-
- 1.1 Amendment to Planning Permit Application No. PLN16/0434.01 - 26 - 56 Queens Parade, Fitzroy North - Construction of two or more dwellings on a lot in a 10-storey building plus two basements, use of part of the land for the sale and consumption of liquor (on premises), partial demolition, reduction of the car parking requirements and alterations of access to a road in Road Zone Category 1.**
-

Executive Summary

1. This report provides an assessment of the application to amend Planning Permit PLN16/0434 (the Permit) relating to land at 26 – 56 Queens Parade, Fitzroy North. The permit allows:

3. On 4 August 2020, Council received notice from VCAT of a request pursuant to section 87A of the Act to amend the Permit. The proposal generally seeks approval for:

Figures 22 and 23 Proposed Queen Parade Renders

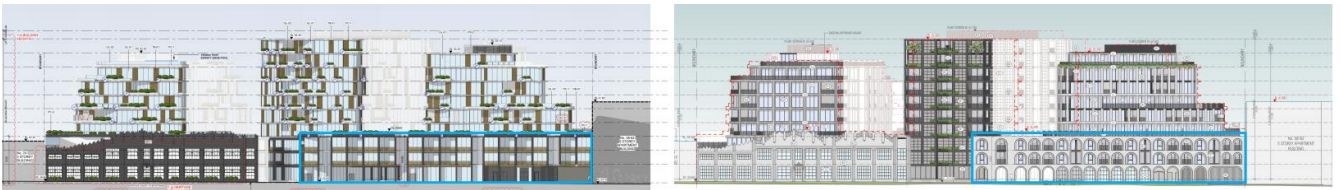
145. The key changes to the Queens Parade Façade relate to the deletion of the organic and curved forms and replaced with more angular and geometric façade articulation

Figures 25 Endorsed heritage building

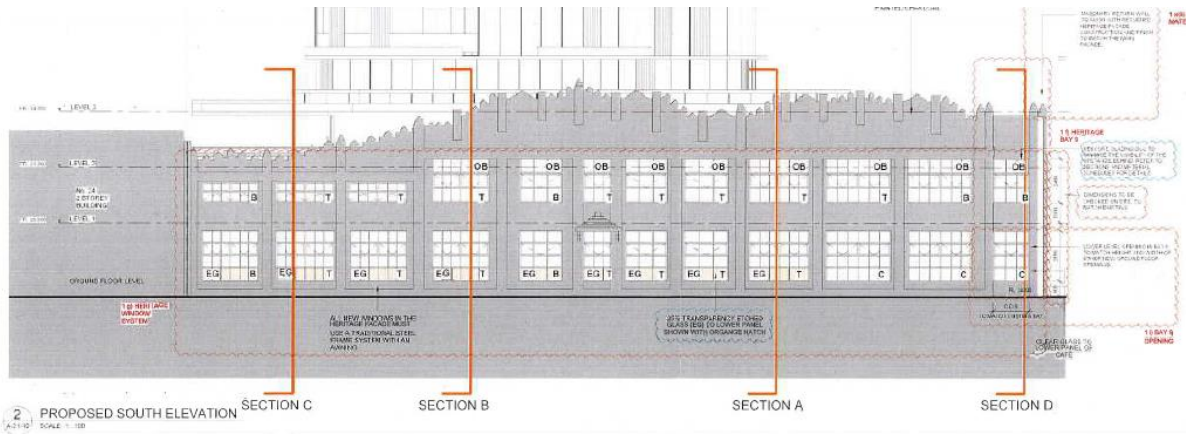
- 147. The use of the heritage façade is retained and now presents as a commercial building rather than having dwellings behind.
- 148. The change in use enables the deletion of the terrace areas previously approved immediately behind the façade and enables floor area to abut to the façade.
- 149. Council’s heritage advisor provided the following comment:

‘I note that the “internal courtyard” behind the retained façade has been deleted and that offices, entry and a food and drink premises (Ground floor) and offices (Level 1) will abut the rear of the retained façade. This will eliminate the concept that only a façade is being retained and will enable some degree of presentation of a three-dimensional building.’

152. It is suggested that the permit applicant clarify these matters prior to the issue of an amended permit

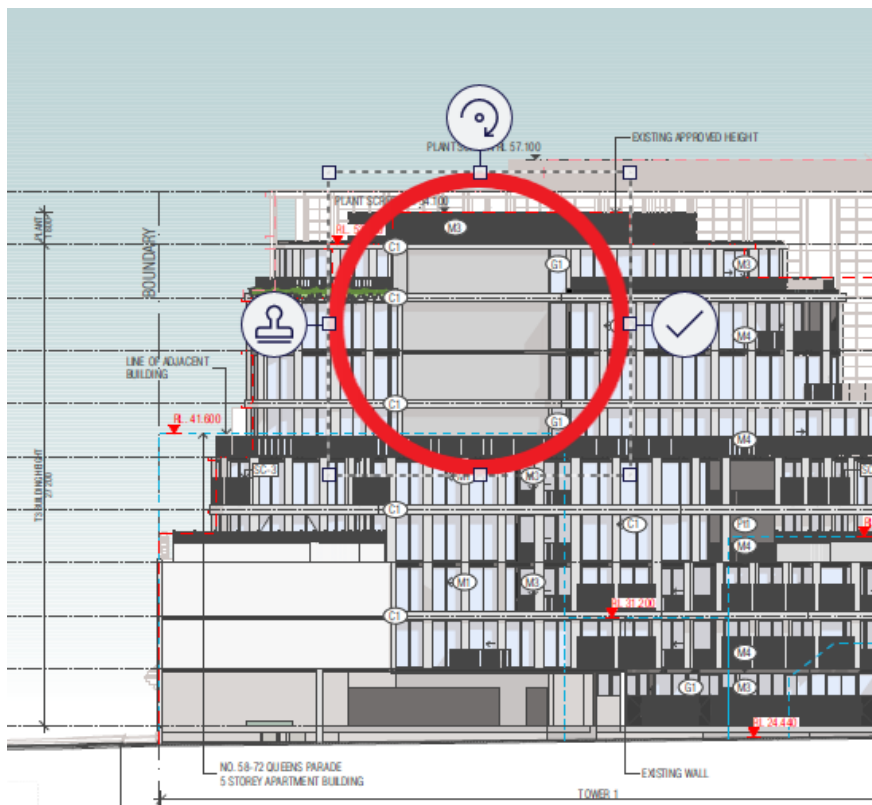
176. The internal spacing of the Towers has narrowed between Towers 1 and 2. The endorsed plans show the separation distance between 11.3 – 17.3m reducing down to 10m.
177. It is acknowledged that the 10m proposed is generous and is a distance which negates the need to screen dwellings. However, Council's urban designer raises concern with this:

The diminishing of landscaping in conjunction to these reduced setbacks reduces separations between tower and design language which seeks to amplify the physical presence of the built form against the earlier stepped form and landscape approach when combined with these reduced setbacks clearly amplifies the perceived bulk form these hinterland locations.

This is at odds with the policy for the site that specifically seeks to, provide an interface to neighbouring residential properties that minimise visual bulk and mass and provided building separation alongside and rear boundaries abutting existing properties'.

Figure 38 Plan annotated by Mr Rob McGauran – Ground floor Plan

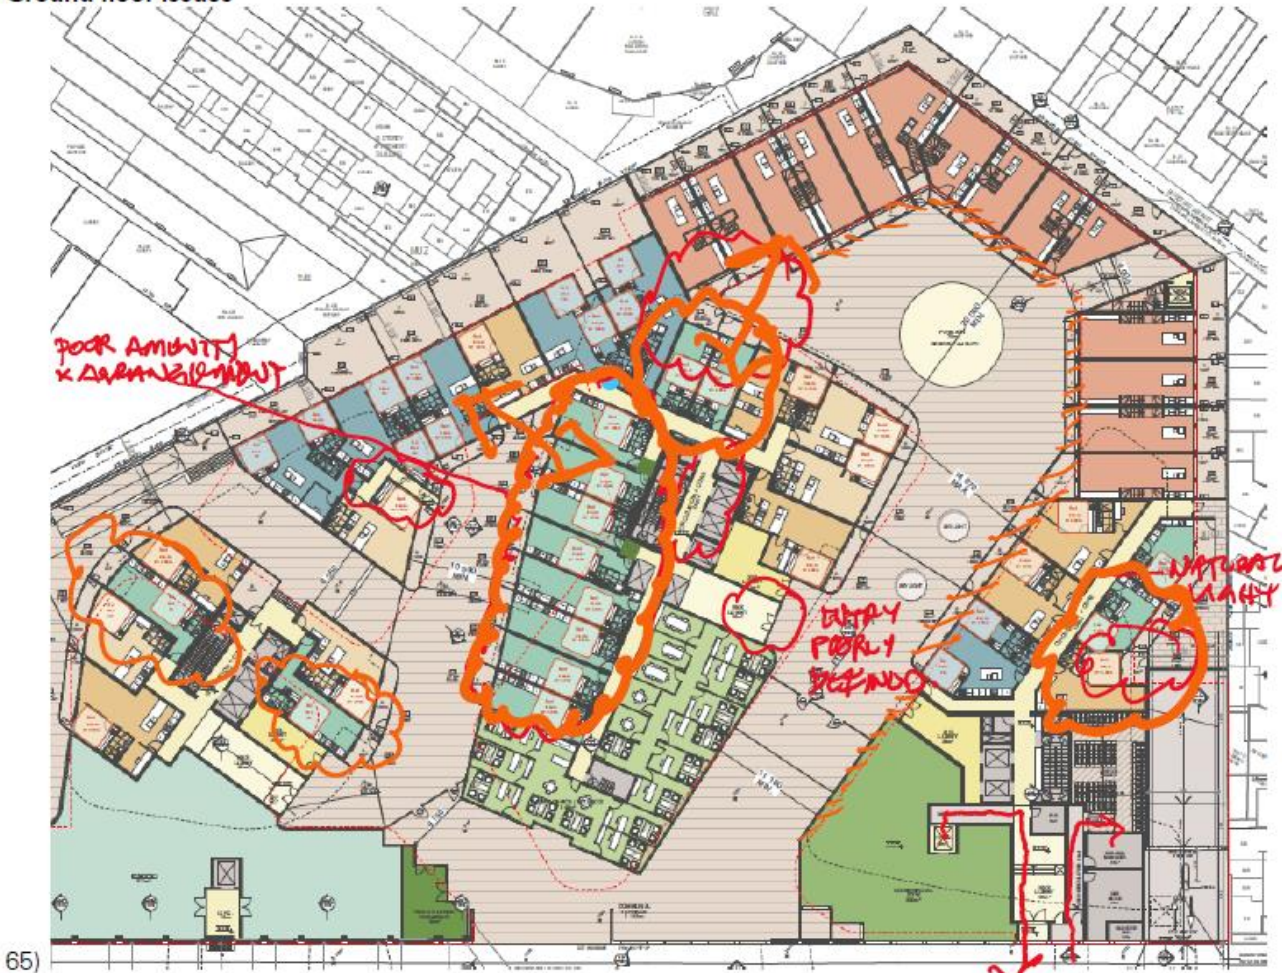
195. At ground floor the following apartments are considered to offer poor internal amenity:

Figure 40 Basement 1 Plan

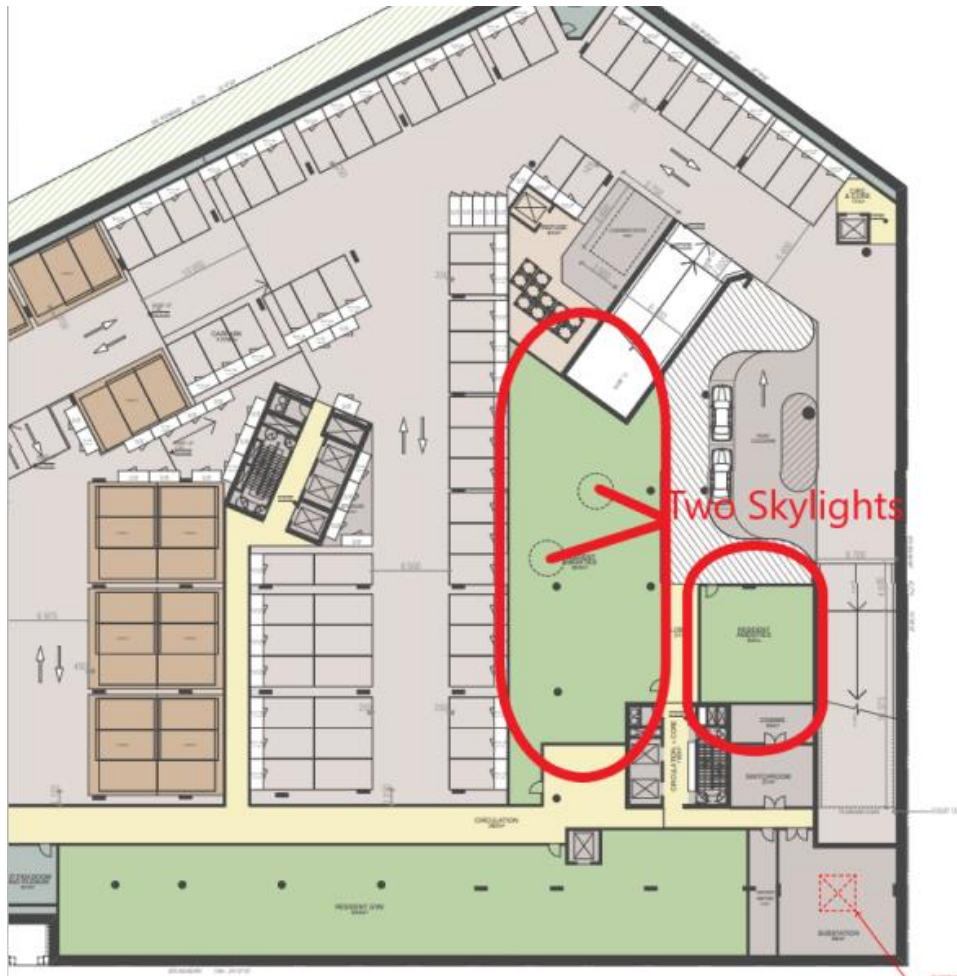
200. These types of areas are typically located in areas where access to daylight and ventilation are readily available. Advice received by Council's ESD advisor states:

- (a) *In addition to poor daylight and amenity to dwellings, the resident's communal areas, amenities and gym are located in the basement with no natural ventilation or daylight, completely reliant on mechanical and electrical systems and very poor amenity. I strongly recommend that these rooms are relocated to ground floor to improve their access to daylight and natural ventilation. It is possible that these spaces could be located on the ground floor courtyard including areas current occupied by poor amenity dwellings. The nature of the larger open plan communal areas would be better suited to the areas in the acute angled building envelope that are unlikely to meet daylight and natural ventilation standards if used as dwellings.*

201. It is recommended that these space be relocated from the basement level.

Figure 41 Level 5 – Tower 1

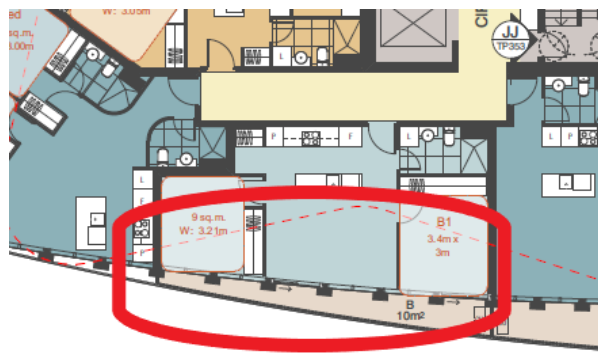
- 208. Objective 6.1 of the DSE Guidelines is *'To ensure access to adequate open space for all residents'*. The guidelines state that *'If a balcony is intended serve as private open space it should be of sufficient size to accommodate outdoor seating, with good connections between these spaces and the building interior.'* Minimum balcony sizes are not specified.
- 209. Most apartments are provided with a minimum 8sqm balcony with direct access off the living room. However some apartments balconies are narrow in depth which should be reconsidered or plans provided which show dimensions and how they can be furnished to show functionality, these specific apartments are shown below:

- 211. These matters could be addressed by condition if an amended permit were granted.
- 212. With respect to communal open space, a large area at ground floor being the areas between buildings is available however these spaces would be in shadow for a significant part of the day not dissimilar to what has already been approved.
- 213. Other areas of communal open space are located at level 8 of Tower 1 offers excellent amenities for the future residents.
- 214. It is not clear from the plans what the area behind the ramp (Tower 3) is meant to be used for, clarification regarding this space should be provided:

Figure 42 Level 6 – Tower 1

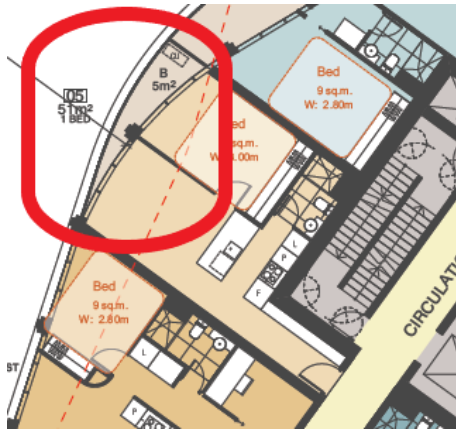
- 210. Additionally, the following apartments have inadequate open space provision:

Figure 45 Level 5 Comparison Document

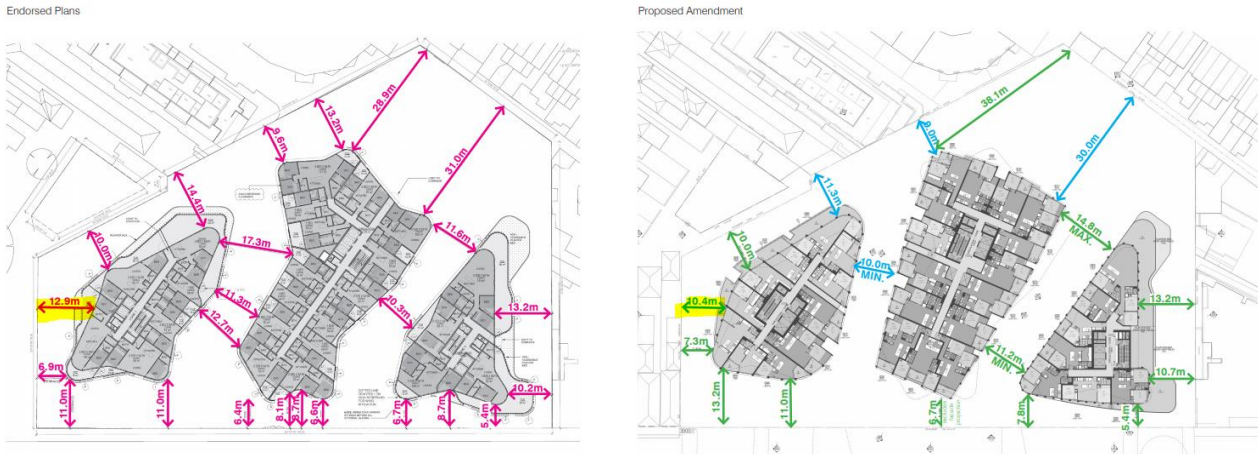
215. The interface with these dwellings at the lower levels (ground to fourth floor) are generally consistent with the endorsed plans, the variation to the setback starts at level 5 where the building is proposed to be constructed 2.5m closer to the common boundary decreasing the setback from 12.9m to 10.4m (see yellow highlight). This is repeated at level 6 with the variation being 14.1m decreasing to 11.6m.

Figure 47 Ground Comparison Document

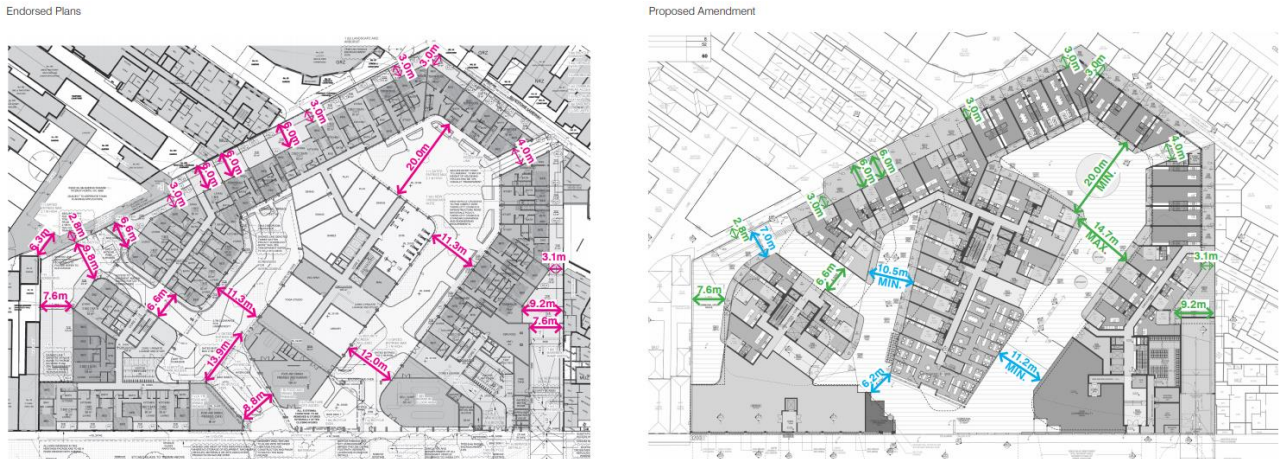
220. The ground level is consistent in its arrangement of 6m setbacks where the site interfaces with the Brunswick Street properties and reducing to 3m to the Grace Lane and Coleman Street properties. The use of this setback area as private open space is consistent with the endorsed plans. These setbacks are consistent at level 1.

Figure 48 Level 2 Comparison Document

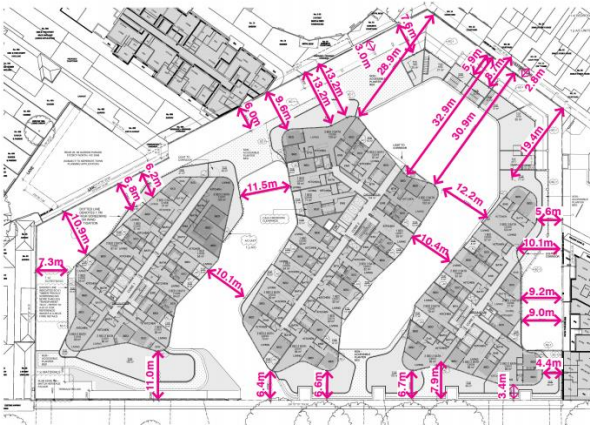
221. At level 2 the setbacks are again consistent with the endorsed showing a setback of 6m where the site interfaces with the Brunswick Street properties and reducing to 4.6m to the Grace Lane and Coleman Street properties.

Figure 52 Level 5 Comparison Document

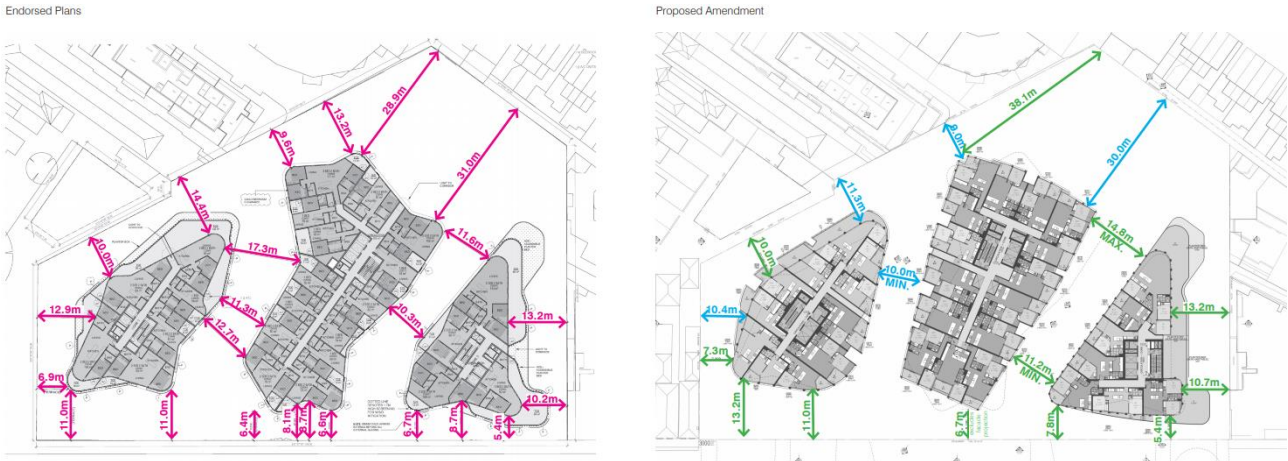
228. The interface with the Coleman Street properties at the upper levels is acceptable. While there is some variation to the setbacks, they remain in the order of 30m from the site boundary.

Figure 55 Level 8 Comparison Document

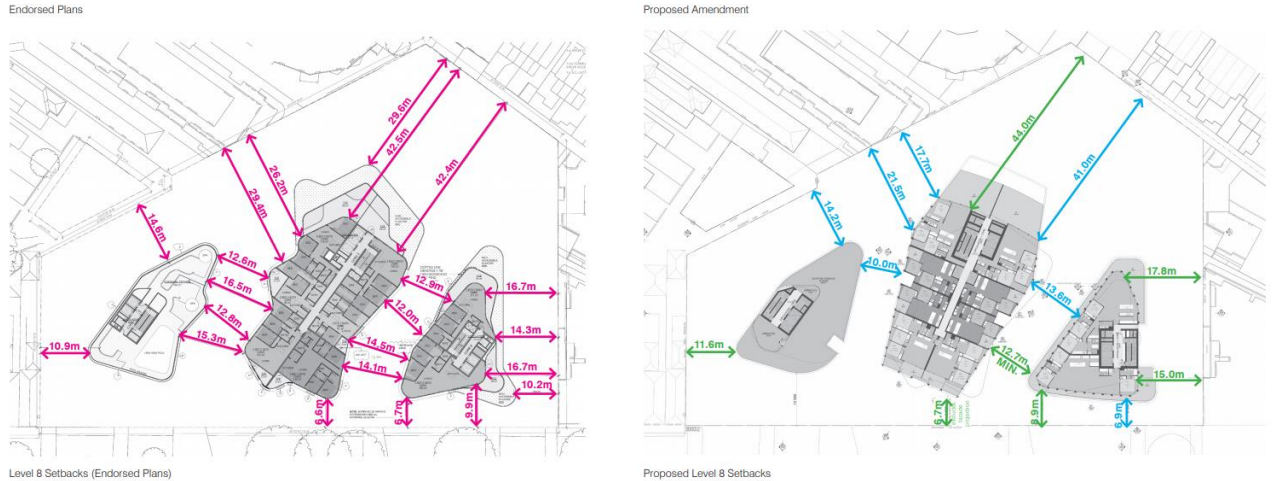
- 229. The eastern boundary interfaces with a 5 storey apartment building at 58 Queens Parade and a series of 3 storey townhouses at 497 Napier Street.
- 230. The proposed amendment adopts the setbacks shown on the endorsed plan and increases these at the upper levels. The eastern elevation is however proposed more angular instead of undulating however on balance this interface is considered to be acceptable.

Figure 56 screen types - proposed

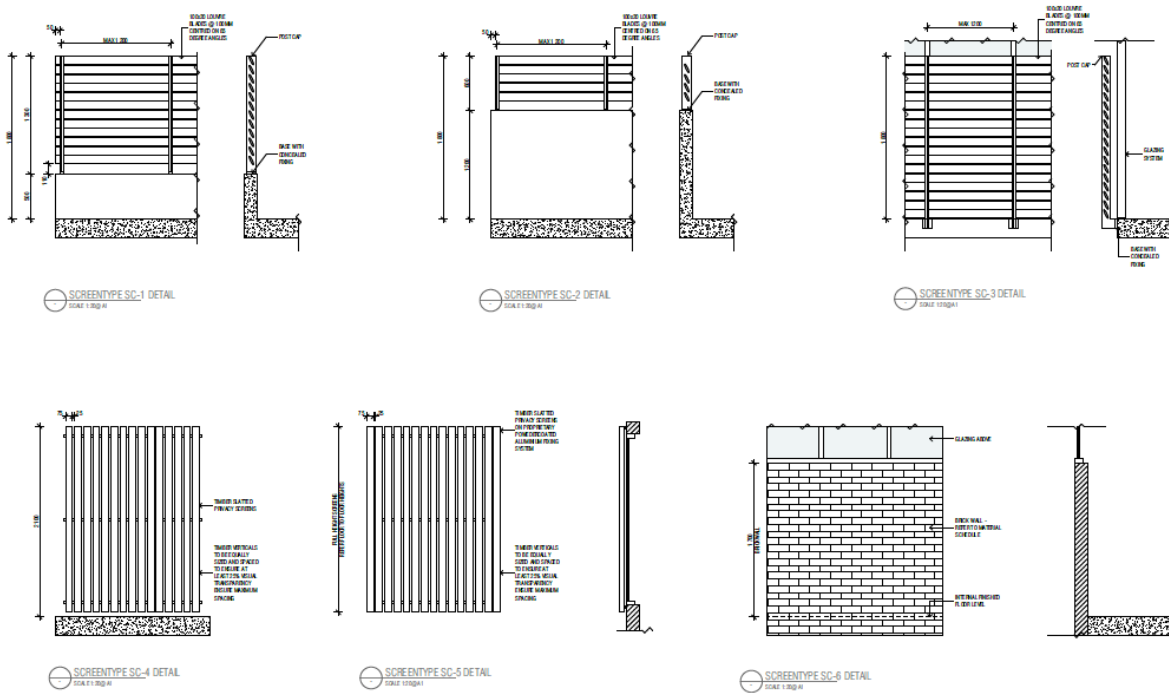
- 231. The amended proposal changes the types of privacy screening and overlooking mitigation but does not intend to undo the extent of privacy protection approved.

232. The plans show screening details of the various screen types proposed for the site, addition options are shown in the comparison document which includes glass fritted. The elevations are not clear where each type of screen is proposed, this could be addressed via a condition on any amended permit. Clarity is also required where the additional screen types as shown in the comparison document are proposed to be used.

Figure 57 Shadows at 9am

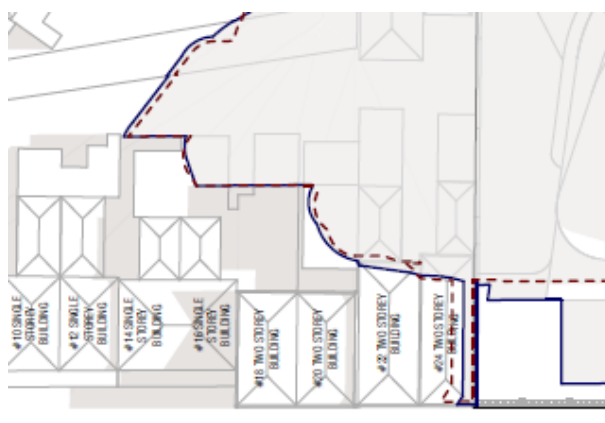
233. The amended proposed results in some variation to the shadowing on the properties to the west and north.
234. More specifically to the west at 9am at the Equinox the following residential properties (20, 22 and 24 Queens Parade) will have an increase in overshadowing with this falling on the rooves of these properties.

Figure 58 Shadow at 10am

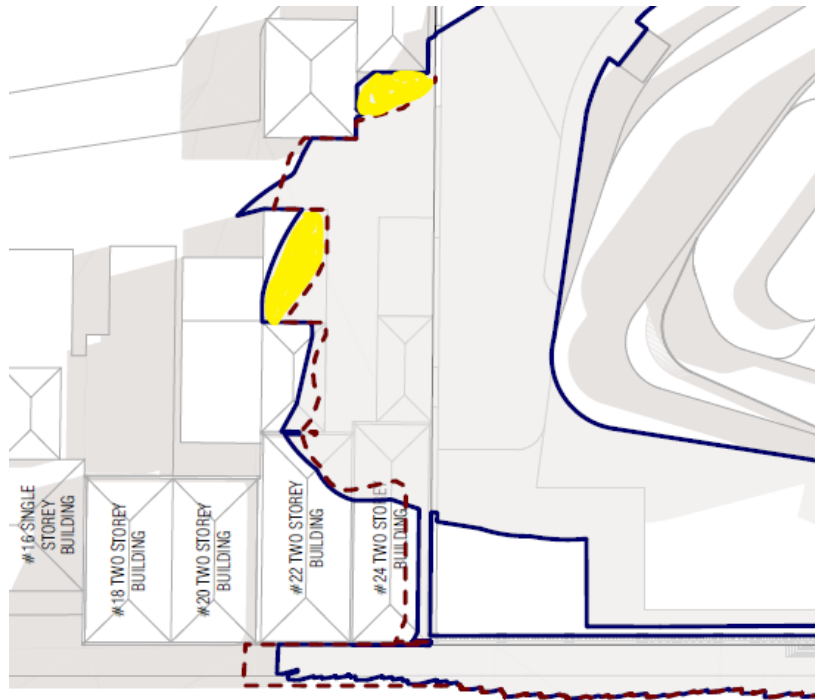
235. The shadow contracts at 10am to affect 22 and 24 under the amended proposal however the overshadowing affects the private open space areas of the two adjoining properties, see figure below (new shown in yellow). It is not clear if these areas are already overshadowed by existing conditions, further information should be provided to ensure minimal new shadowing on these properties.
